Planning Application 19/01818/OUT

On behalf of our clients Bow Brickhill Parish Council, I am writing to set out their significant objection to the above application.

Figure 1: Queue lengths

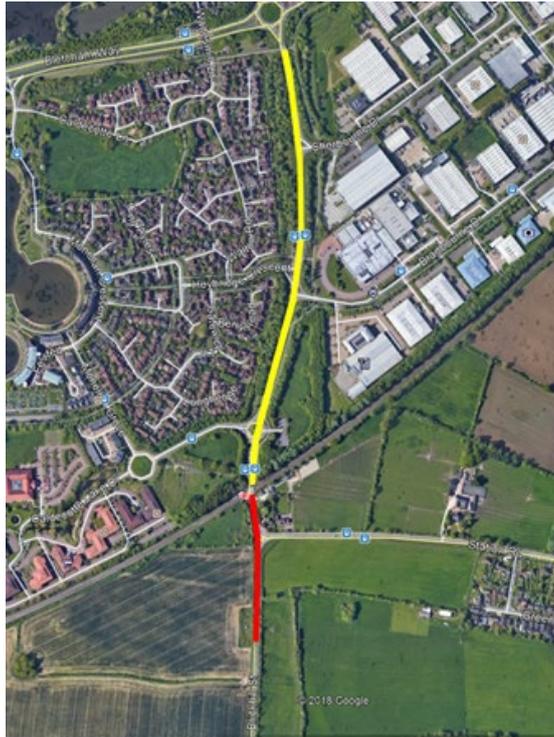
The TA uses queue count data from one day only that identifies a maximum queue in the AM peak of 45 vehicles to the south along Brickhill Street when the level crossing is shut. In the PM peak hour there is a queue of 136 vehicles to the north.

The length of these queues (assuming 6m per vehicle) is shown below in red (south) and yellow (north).

The TA concludes that the development will “only” add 3 or 4 vehicles during the peak hours to the existing queueing (identified in the SPD as an important concern to local people) and so no solution is proposed. Moreover, there is no analysis of the number of HGV’s queueing nor the likelihood that the level crossing will be shut more frequently in the future as a result of the East West Rail project.

Figure 2: existing Redway

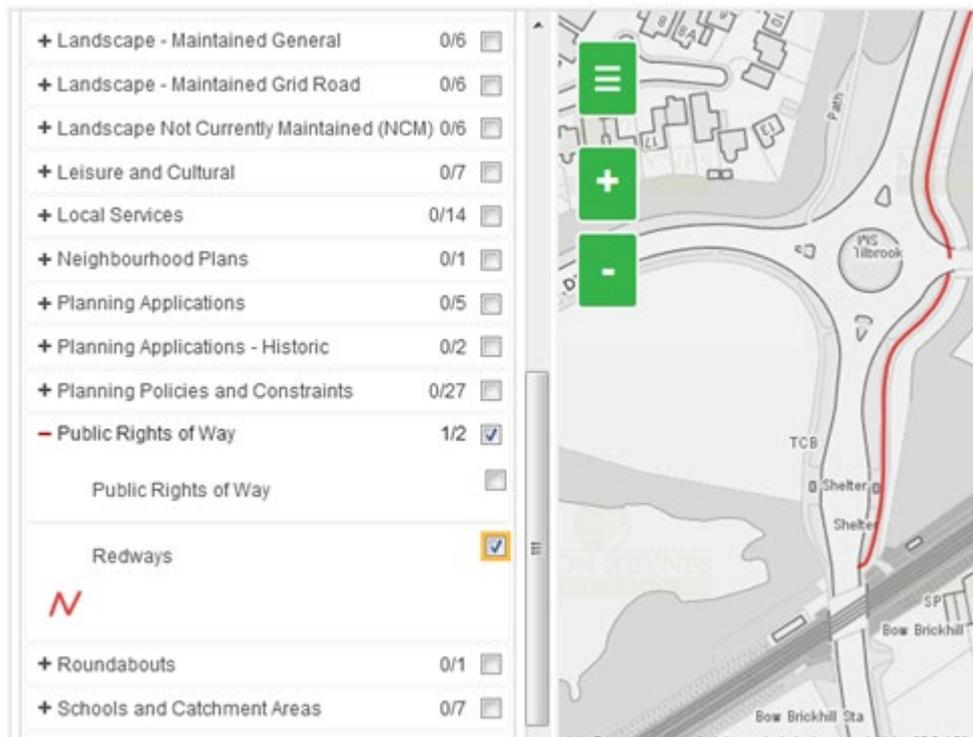
A Redway is proposed along the western side of Brickhill Street from the A5/Watling Road Roundabout to the proposed access roundabout. From there it routes through the site and reappears at the level crossing. The TA accepts that this detour adds 400m or 2 minutes to a cycle journey.

This does not accord with the SPD (3.5.11), which states that a “new redway will be provided adjacent to Brickhill Street within the grid corridor”.

However, the Redway proposed does not link into the existing network.

Appendix 1: Network Rail proposals

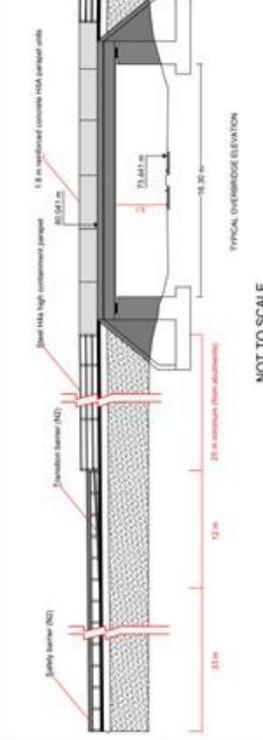
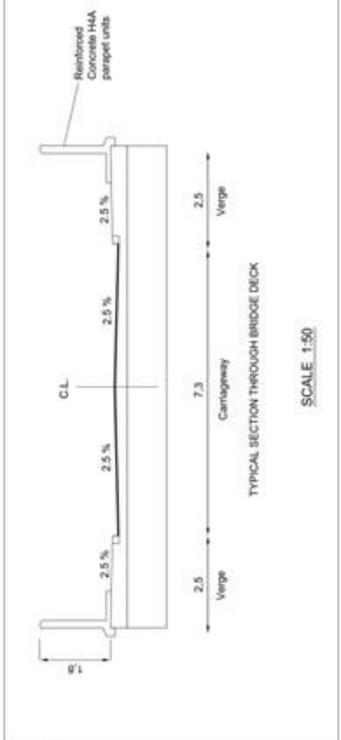
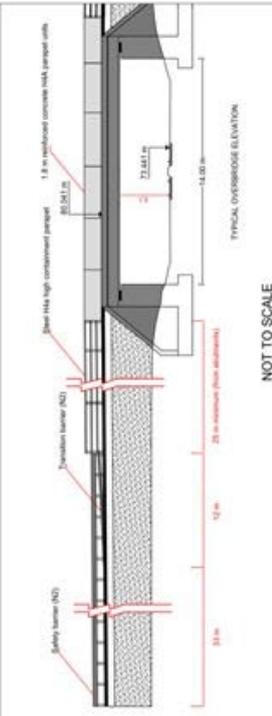
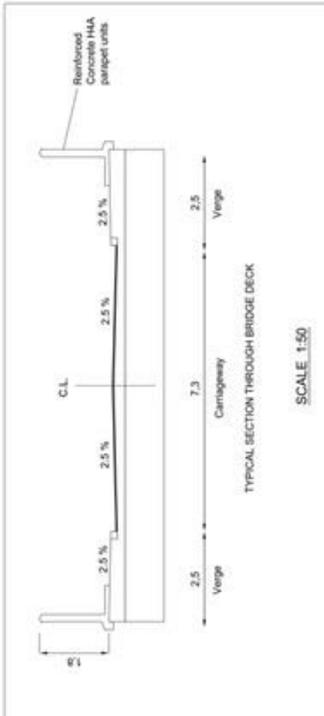
- The proposal would stifle the ability to provide a railway crossing at the nearby crossing that would meet the requirements of Network Rail. It is likely that the development area will need to reduce in order to facilitate one of these solutions (at appendix 1);

There are already significant delays at the Bow Brickhill Rail crossing with the gates closed for 14 to 15 minutes per hour. This excludes freight trains and in any event is expected to double by 2024 when the upgrade works are complete. Given the existing delays and the fact that this will only increase as train numbers intensifies (with significant flows of traffic towards the railway crossing associated with the development), it seems imperative that any development at the site includes measures to ensure at the very least that the impact doesn’t become any worse due to development, absent this then the proposals would not comply with relevant transport policies within Plan:MK.

It is our understanding that Network Rail have prepared two schemes (at appendix 1) that would meet their requirement these are shown below. Clearly these options would require land to be safeguarded within the site area.
